FORD POWELL CARSON

MEETING MINUTES

🏠	Location:	Zoom Meeting
📅	Meeting Date:	7/29/2021
🕒	Meeting Time:	4:00pm
📁	Project:	Northeast Lakeview College STEM Education Building 96601-12
👤	Prepared By:	Hector J. Machado, Senior Associate

GRADING PLAN

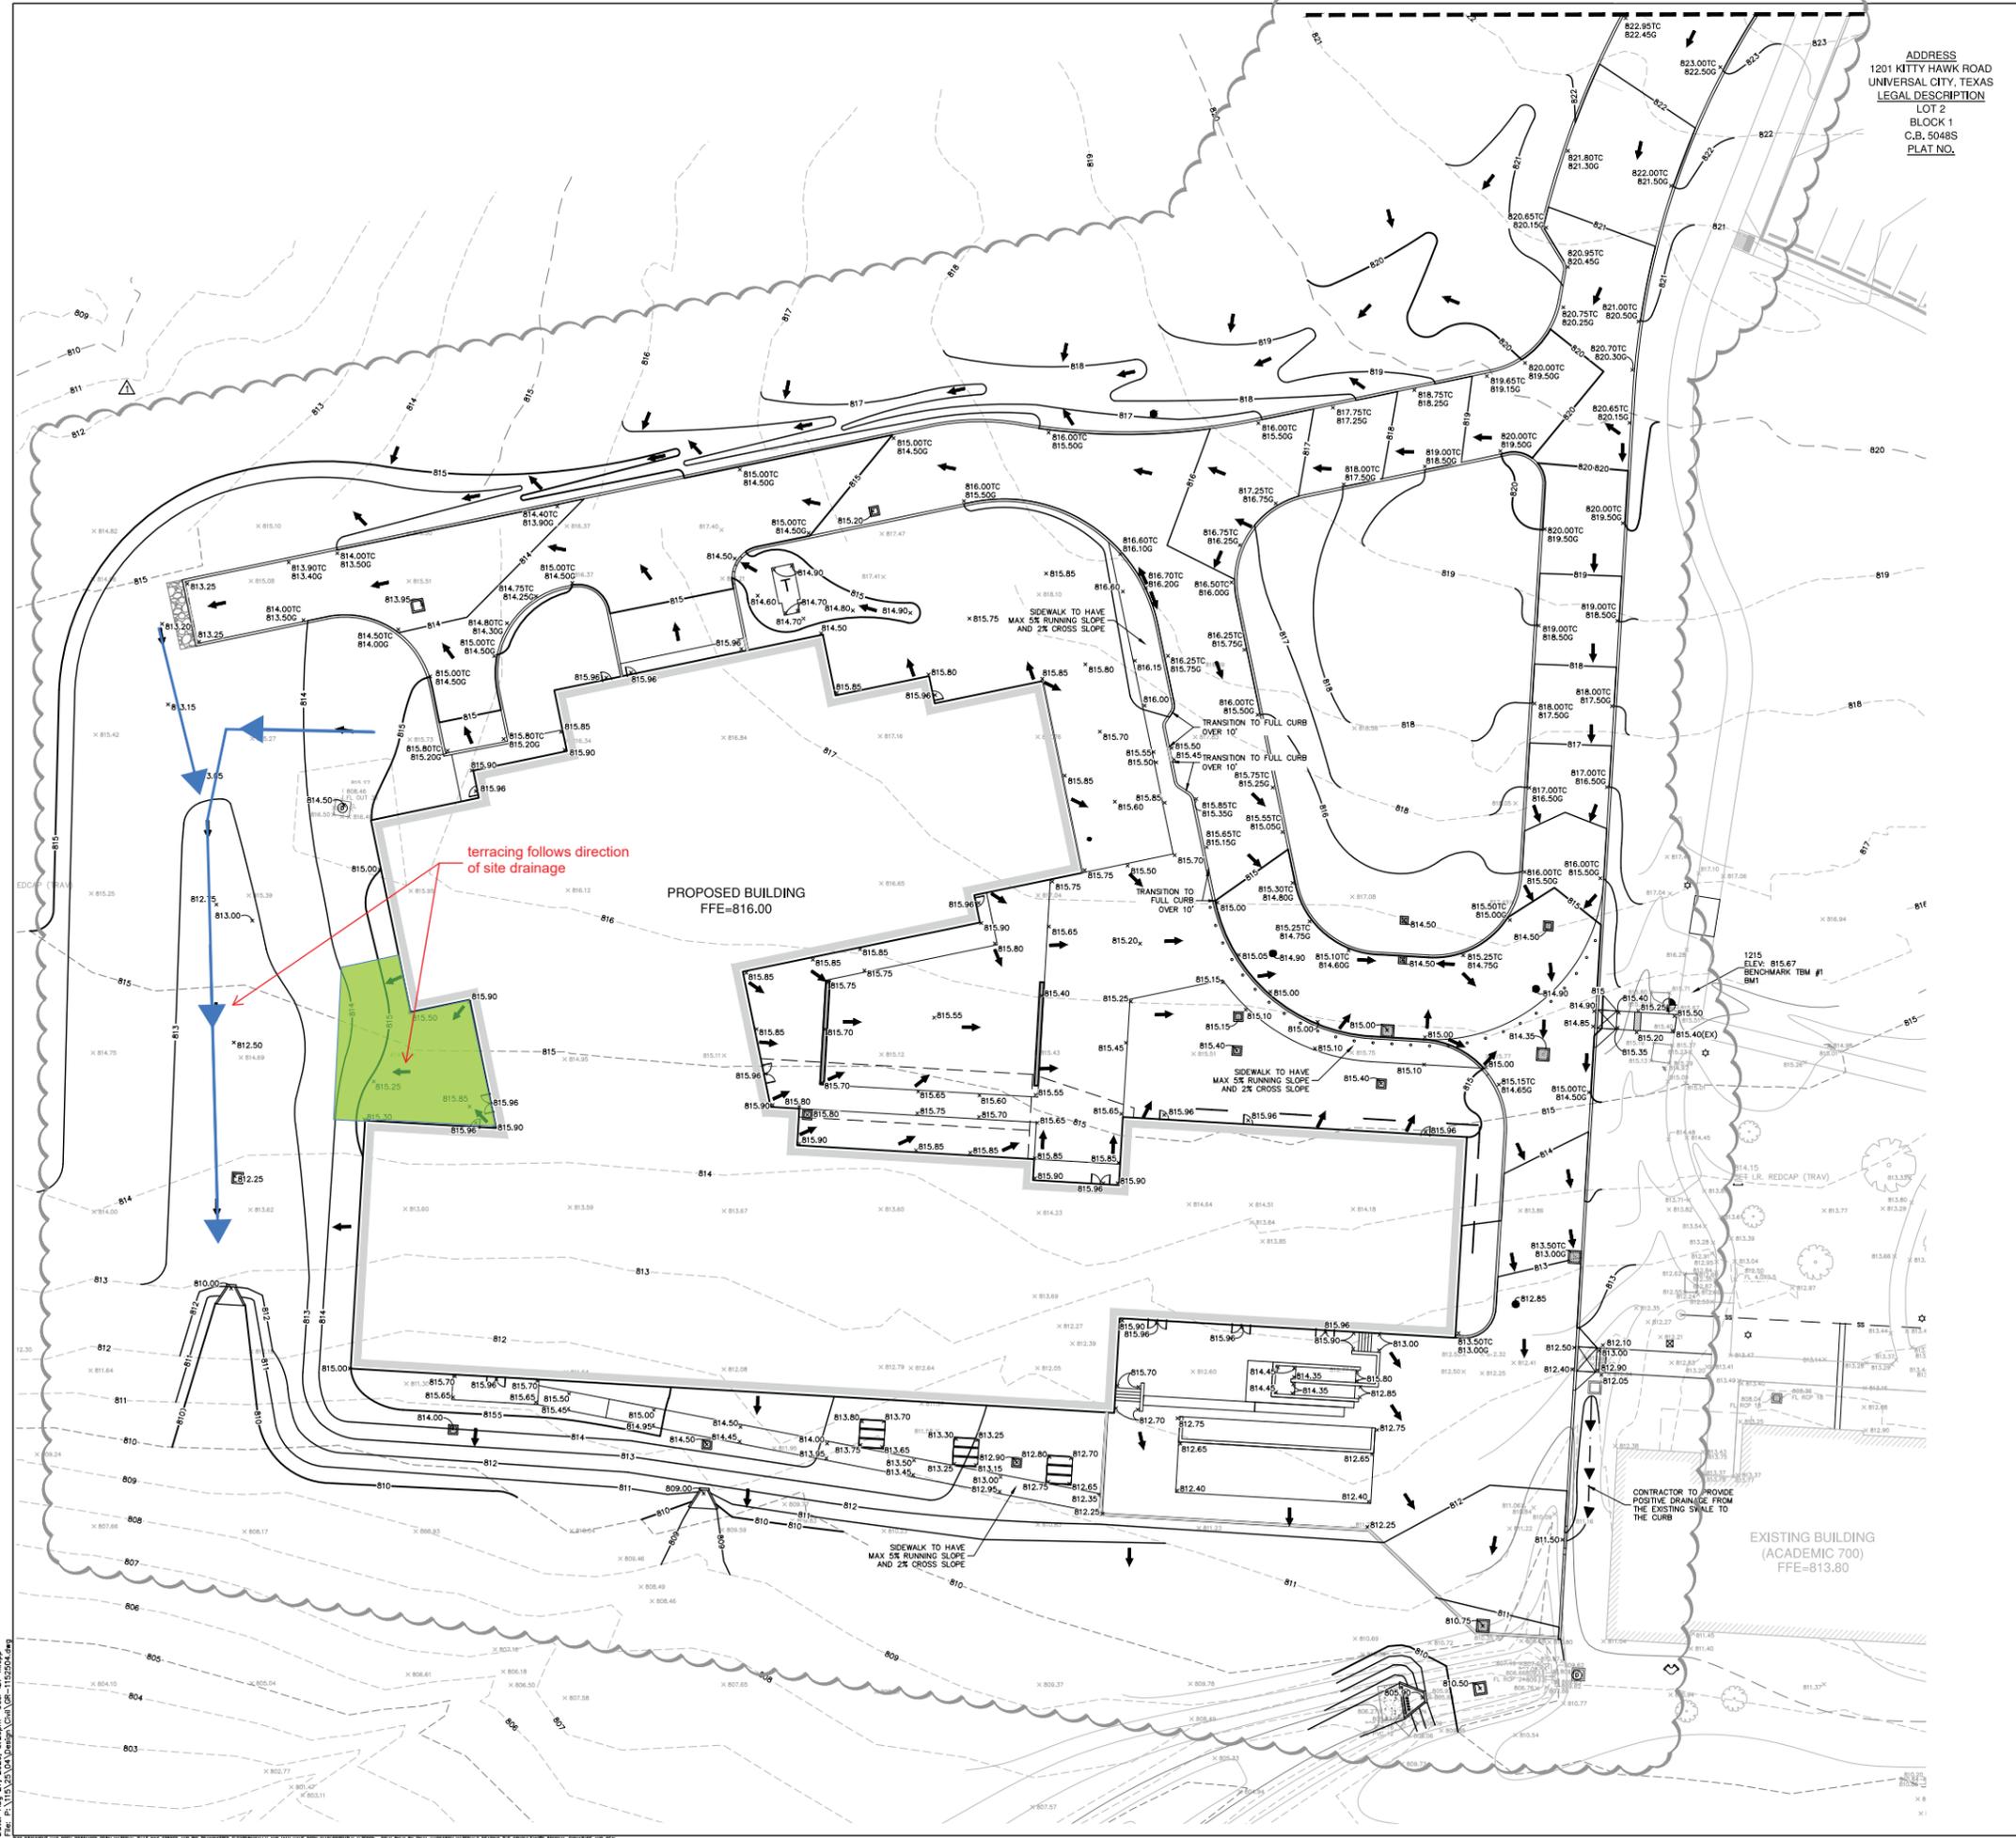
terracing follows direction of site drainage

ENLARGED PLAN

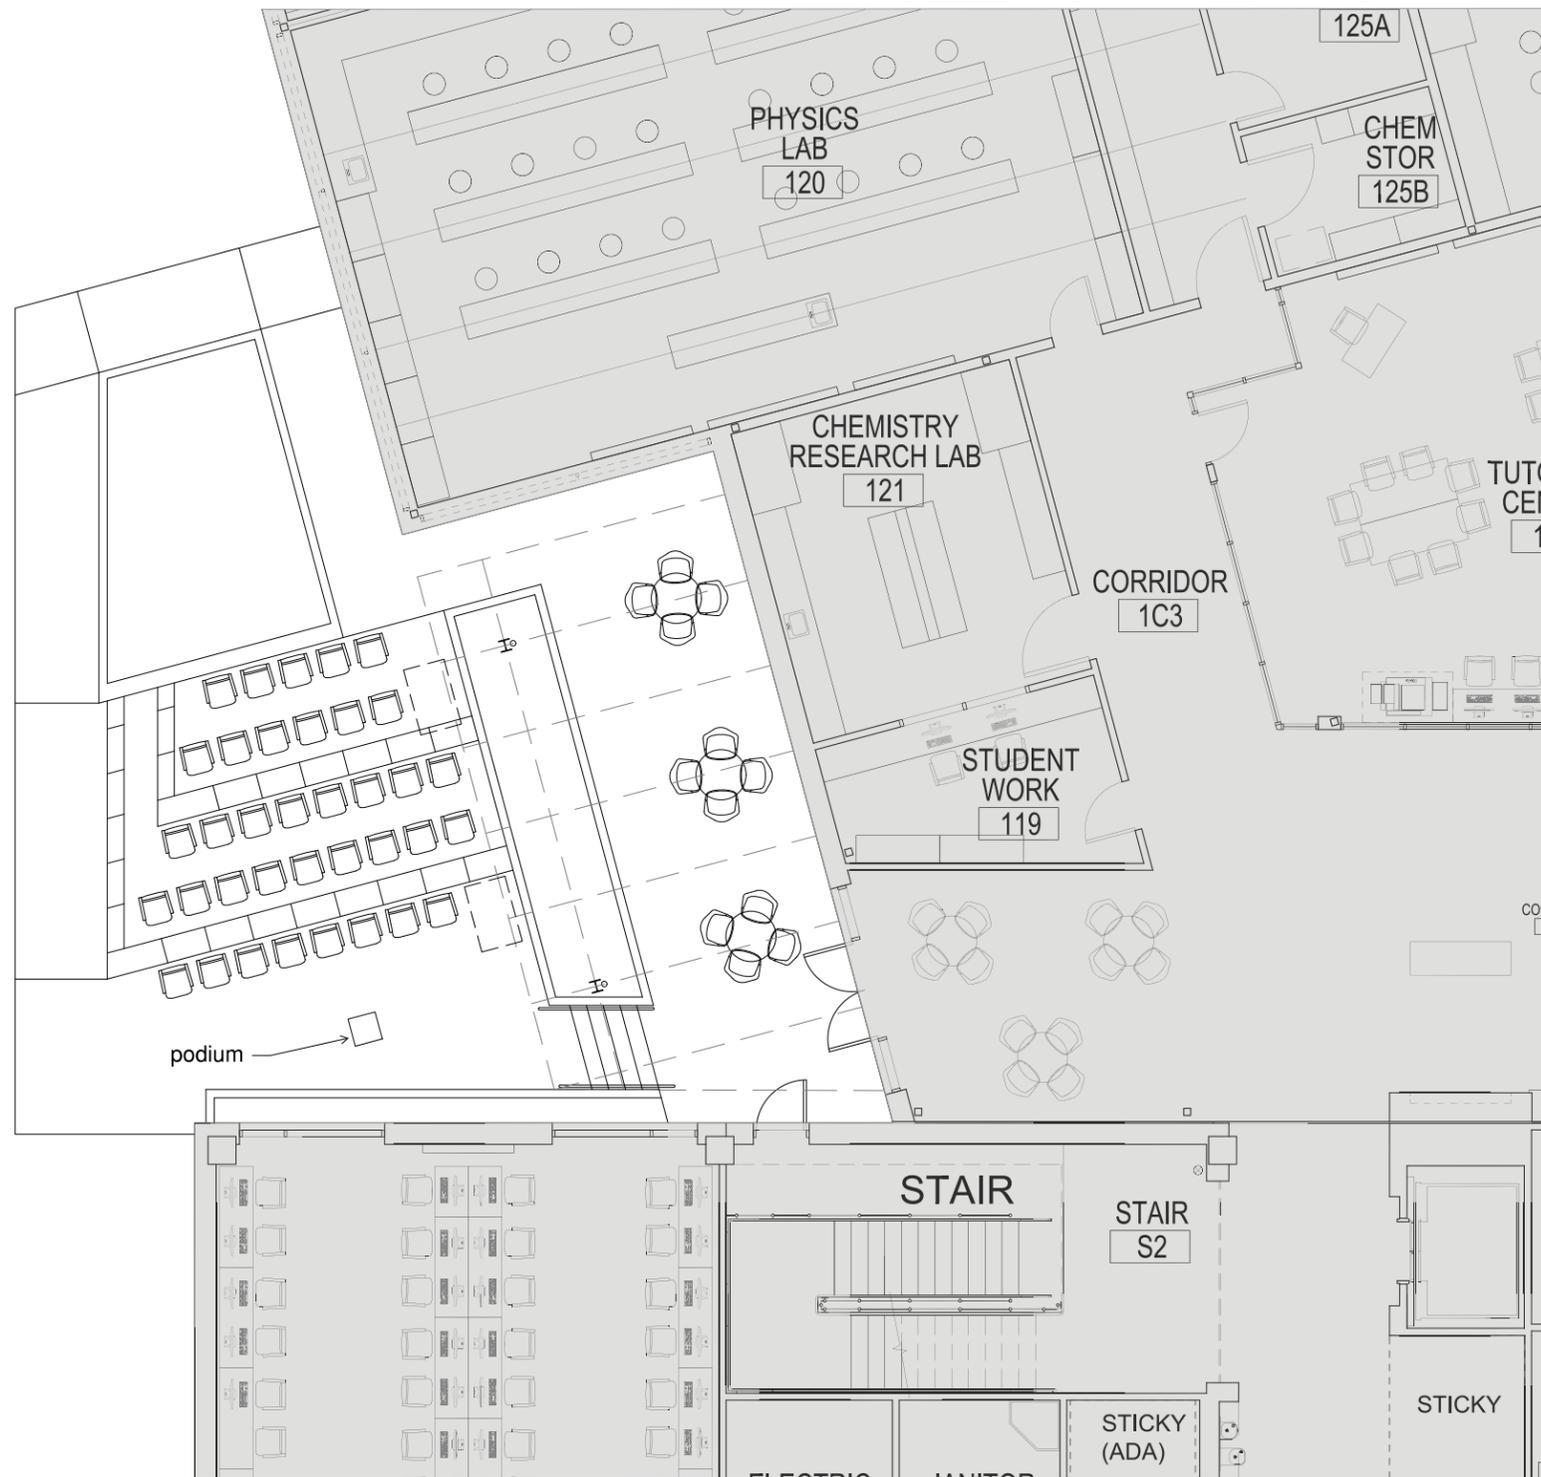
7. One or possibly two wireless access points will be provided. FPC to coordinate with True North.
8. Dr. Garcia requested electrical convenience outlets be added at several planter wall locations for presenters and a small band. (See last page for markup with outlet locations).

plan 1/8" = 1'-0"

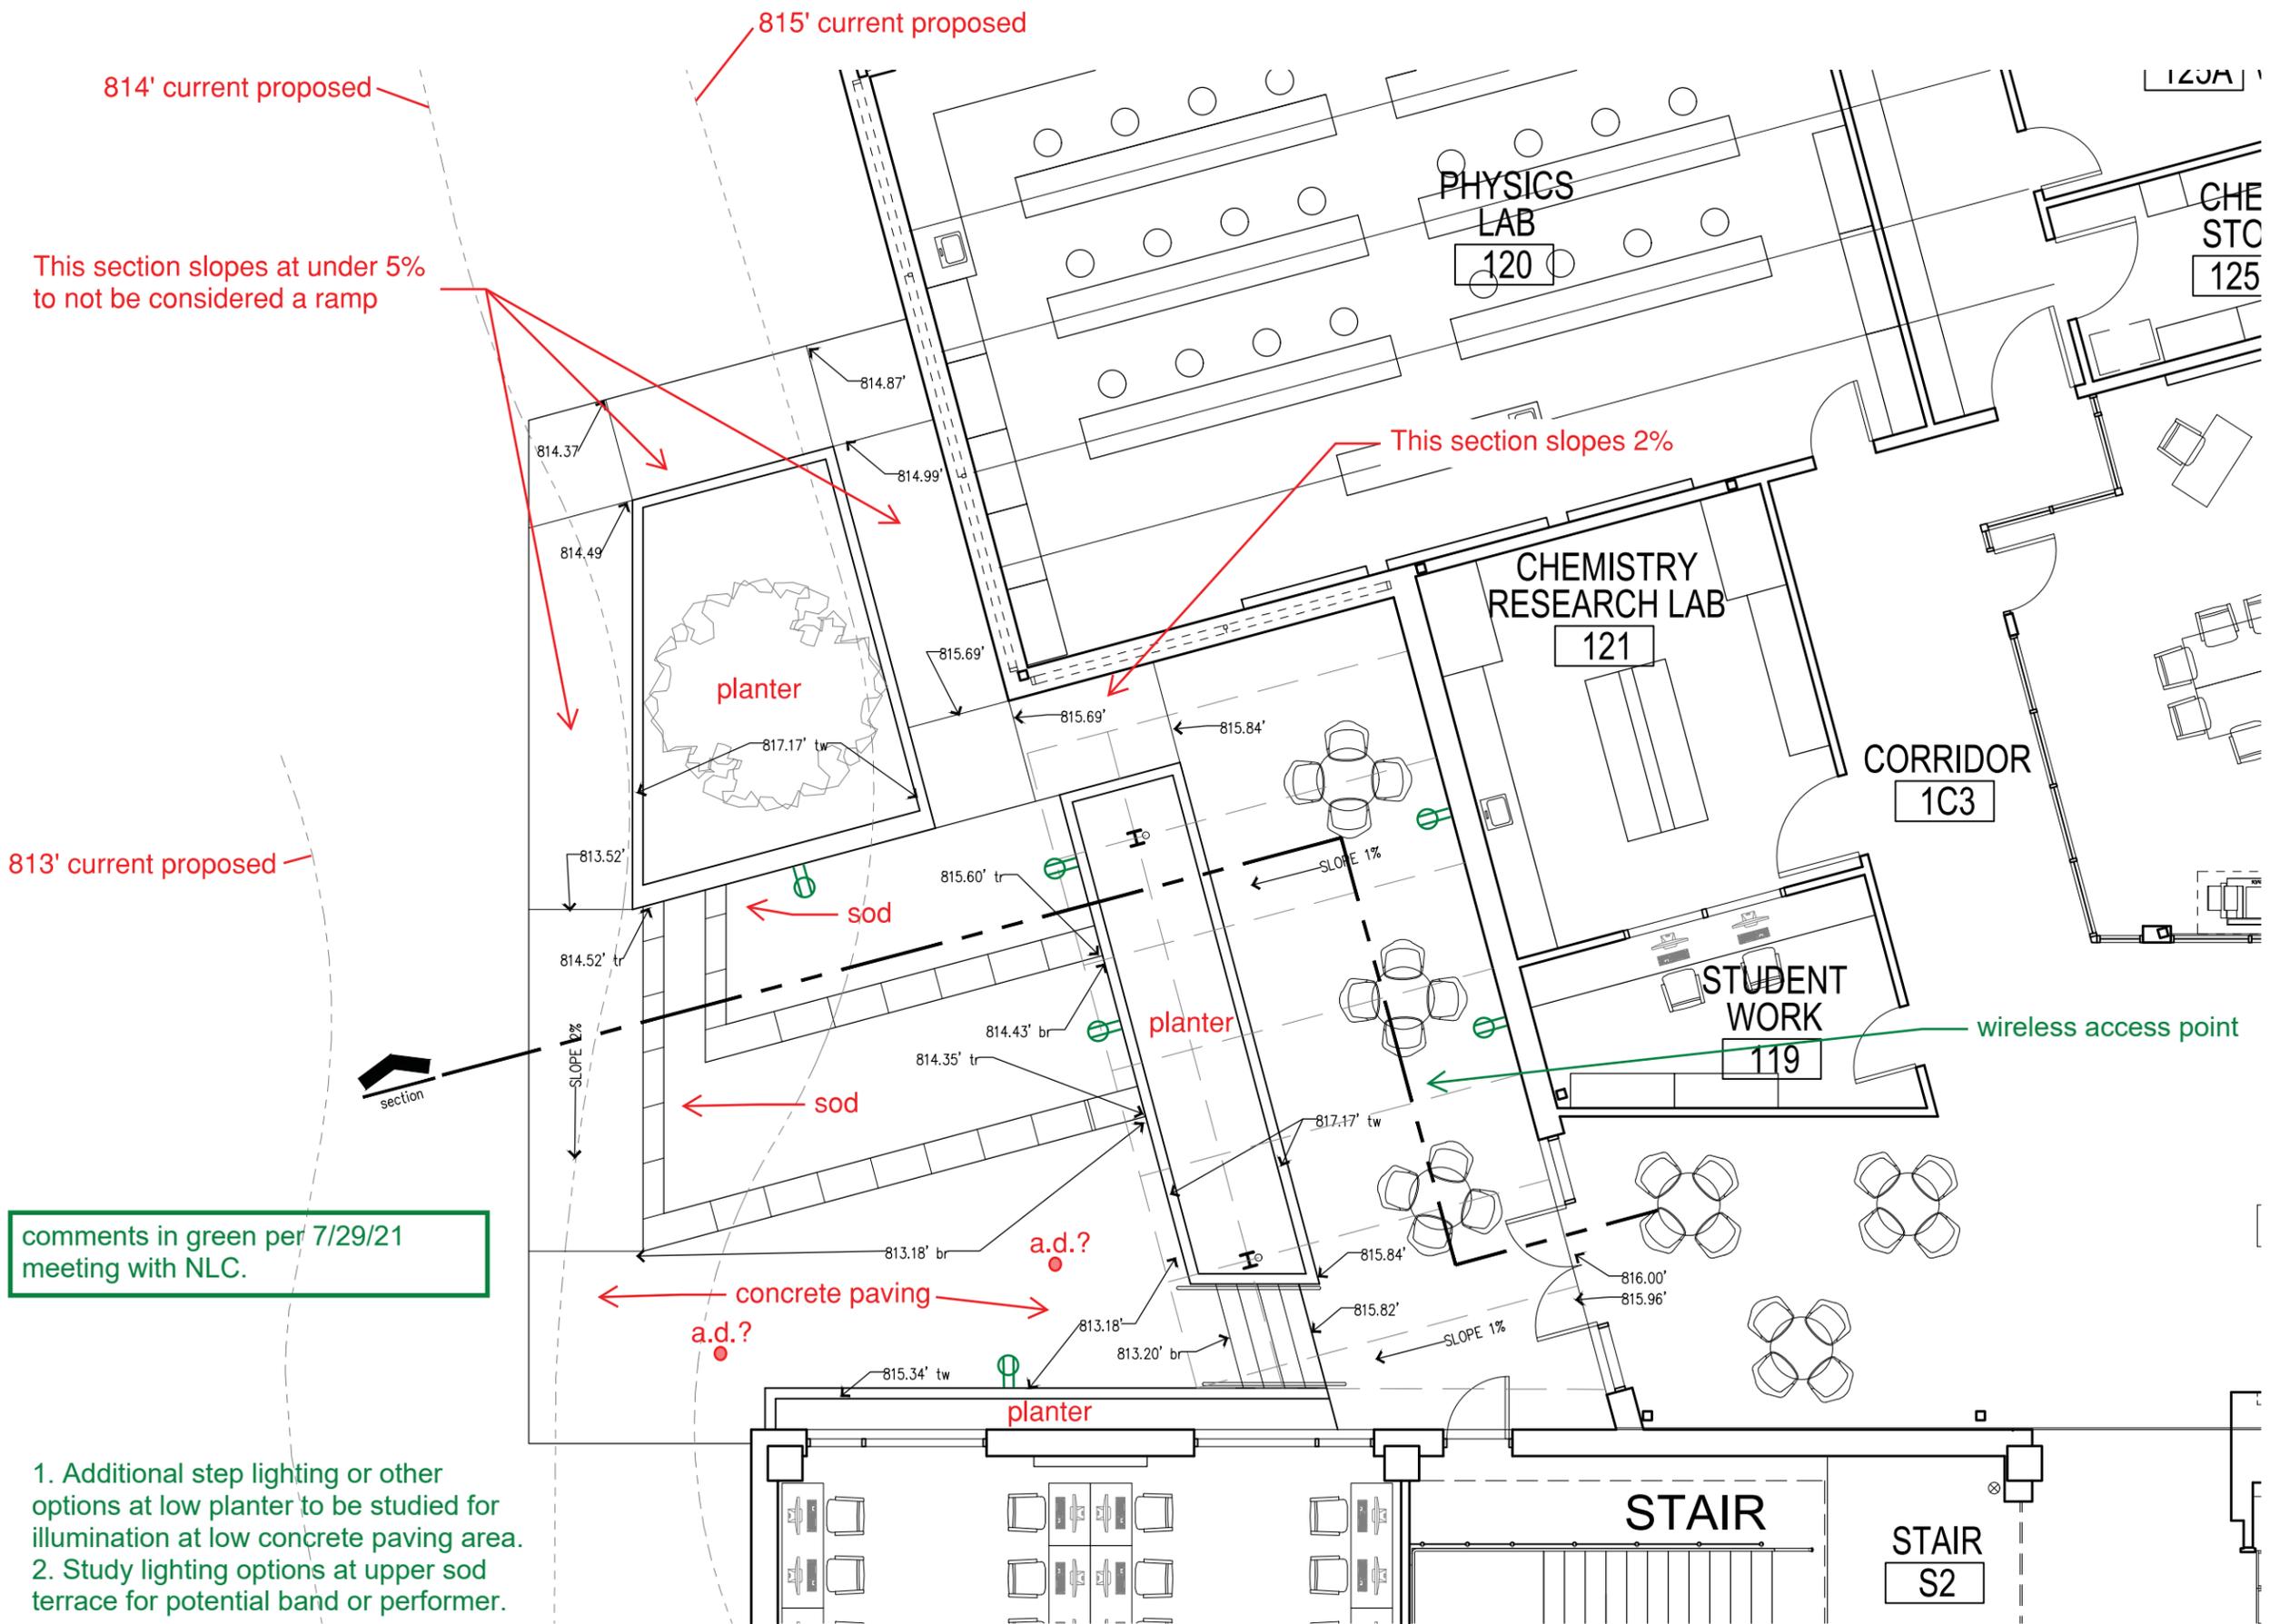
comments in green per 7/29/21 meeting with NLC.

1. Additional step lighting or other options at low planter to be studied for illumination at low concrete paving area.
2. Study lighting options at upper sod terrace for potential band or performer.
